# Access Compliance Report

## Public Rights-of-Way

### (Curb Ramps)

Intersection ID: 23574	Main Street: CARMEL_RD	Cross Street: QUAIL_HOLLOW_RD	Location: SW
ADA ID: 9C42201BA204	Ramp Type: Perp	Initial Pass/Fail: Fail	Overall Compliance: No
		Severity Score: 8.75

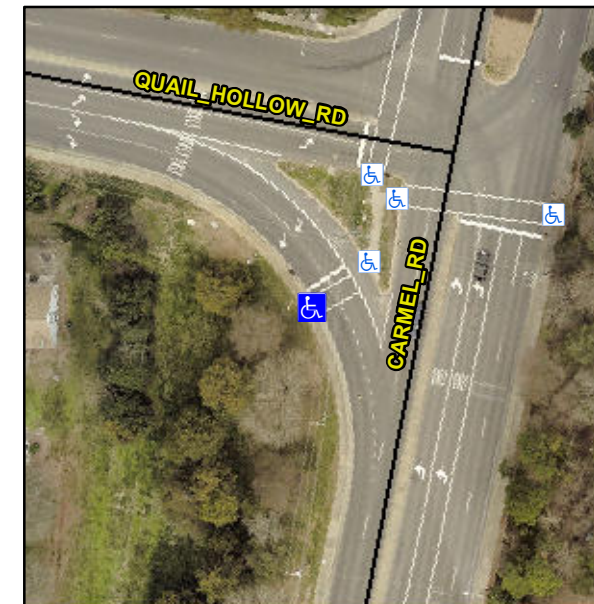
**Not Found, R304.5.1**

Compliance	Description	Data	Compliance	Description	Data
N/A	Ramp Length (in)	59.0	Yes	Ramp Slope (%)	6.8
No	Ramp Width (in)	45.5	Yes	Ramp XSlope (%)	1.1
N/A	Flare Type LT	N/A	N/A	Flare Type RT	N/A
N/A	Flare Slope LT (%)	N/A	N/A	Flare Slope RT (%)	N/A
N/A	Flare Traversable LT?	N/A	N/A	Flare Traversable RT?	N/A
N/A	Landing Length (in)	N/A	N/A	DWS Provided?	N/A
N/A	Landing Width (in)	N/A	N/A	DWS Contrast?	N/A
N/A	Landing Slope (%)	N/A	N/A	DWS Length (in)	N/A
N/A	Landing X Slope (%)	N/A	N/A	DWS Full Width?	N/A
N/A	Landing Curb? (Y/N)	N/A	N/A	DWS Offset (in)	N/A
N/A	Shared Landing?	N/A			
N/A	Gutter Ponding?	N/A	N/A	Gutter Slope (%)	N/A
N/A	Gutter Lip Ht (in)	N/A	N/A	Gutter X Slope (%)	N/A
N/A	Painted X Walk1?	Yes	N/A	Painted X Walk2?	N/A
	X Walk 1 Direction	To NE		X Walk 2 Direction	N/A
N/A	X Walk 1 Width (in)	110.0	N/A	X Walk 2 Width (in)	N/A
	X Walk 1 Slope (%)	0.4		X Walk 2 Slope (%)	N/A
	X Walk 1 X Slope (%)	0.1		X Walk 2 X Slope (%)	N/A

N/A	Ramp inside XWalk1?	Yes	N/A	Ramp inside XWalk2?	N/A
	Road Slope (%)	N/A	N/A	Clear Space?	N/A
	Road X Slope (%)	N/A	N/A	Clear Space to XWalk (in)	N/A
N/A	Any Obstructions?	N/A	N/A	Storm Grate/Utility Hazard?	N/A
	Obstruction Type			Storm Grate/Utility Type	
		N/A			N/A
			Yes	Surface Condition? (G/P)	Good

**Remove & Replace Entire Ramp.**
